SUBJECT: MILLSTONE POWER STATION, UNIT NO. 2 - ISSUANCE OF AMENDMENT
RE: ADMINISTRATIVE CHANGES AND CORRECTIONS TO THE TECHNICAL
SPECIFICATIONS (TAC NO. MF3870)

AMENDMENT TO RENEWED FACILITY OPERATING LICENSE

Amendment No. 320
Renewed License No. DPR-65

SAFETY EVALUATION BY THE OFFICE OF NUCLEAR REACTOR REGULATION

FIGURE 2.2-2 Local Power Density - High Trip Setpoint Part 2 (QR_2 Versus Y_1)

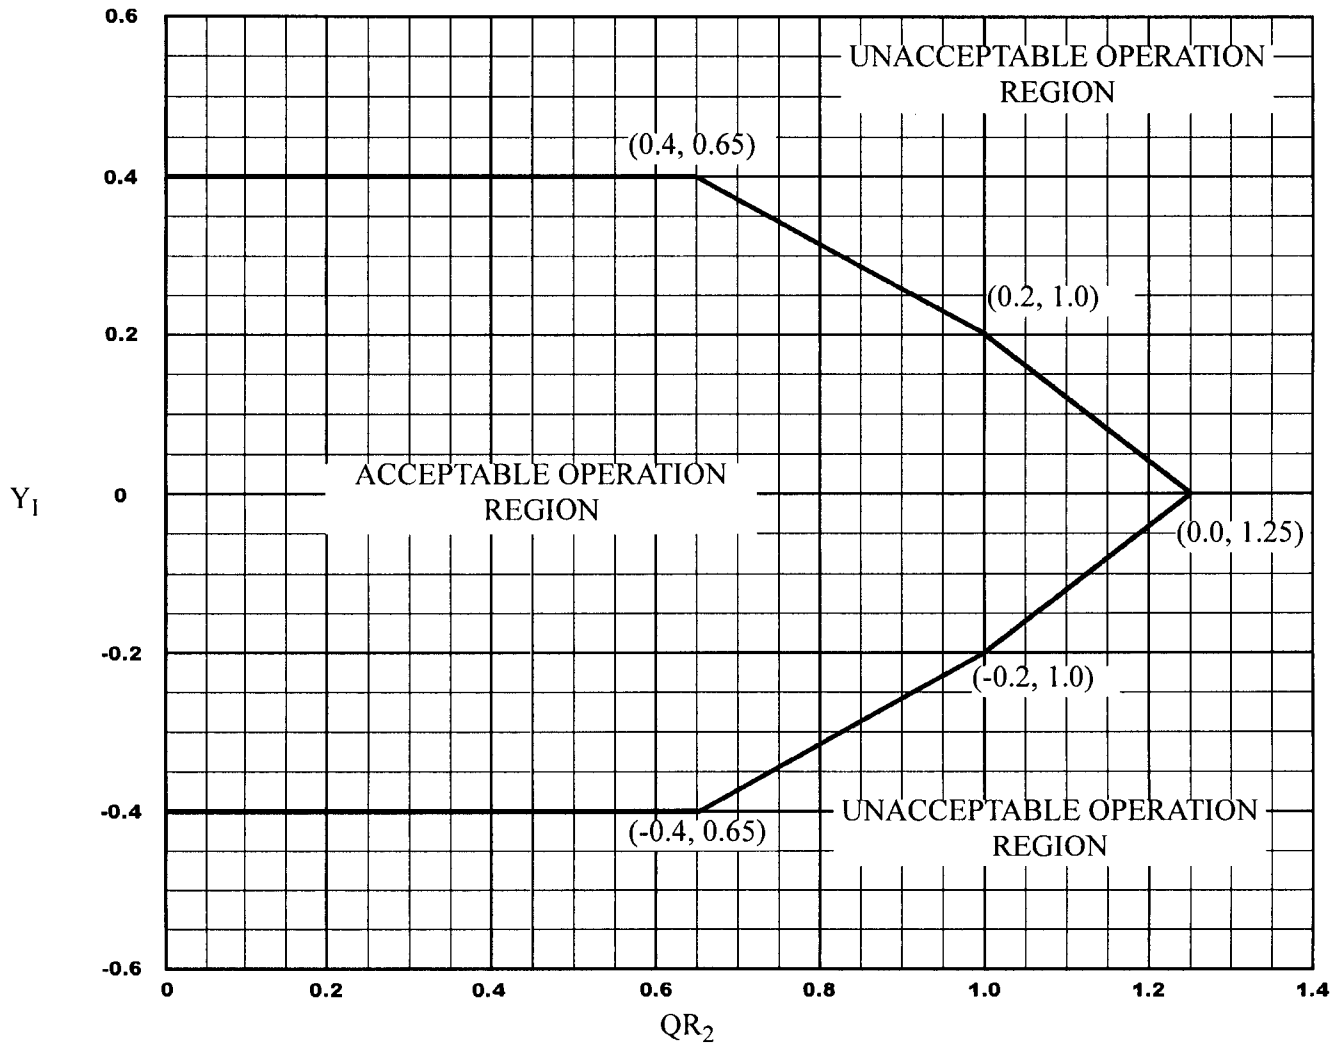
3.2 Correction to Figure 2-2-2

Replace figure number "2-2-2" on TS Page 2-7 with "2.2-2."

The figure number on TS Page 2-7 for Figure 2-2-2, "Local Power Density - High Trip Setpoint Part 2 (QR₂ Versus Y₁)," is incorrect. This is a typographical error.

3.3 Corrections to Figure 2-2-2 and 2.2-3

Replace "Y₁" (Y sub 1) in two locations in Figure 2-2-2 (to be relabeled as Figure 2.2-2 as noted in section 3.2, above) and in four locations in Figure 2.2-3, "Thermal Margin/Low Pressure Trip Setpoint Part 1 (Y₁ Versus A₁)," with "Y_I" (Y sub I).

There are six locations in these 2 figures where AXIAL SHAPE INDEX for the trip signals in the reactor protection system, is incorrectly labeled as "Y₁" (Y sub 1). As shown in the Definitions section of the MPS2 TSs, the symbol for AXIAL SHAPE INDEX for the trip signals in the reactor protection system, is "Y_I" (Y sub I).

This proposed editorial change is corrective in nature and does not involve any physical changes to SSCs in the plant, or the way SSCs are operated or controlled. Therefore, the proposed change is acceptable.

This proposed editorial change is corrective in nature and does not involve any physical changes to SSCs in the plant, or the way SSCs are operated or controlled. Therefore, the proposed change is acceptable.
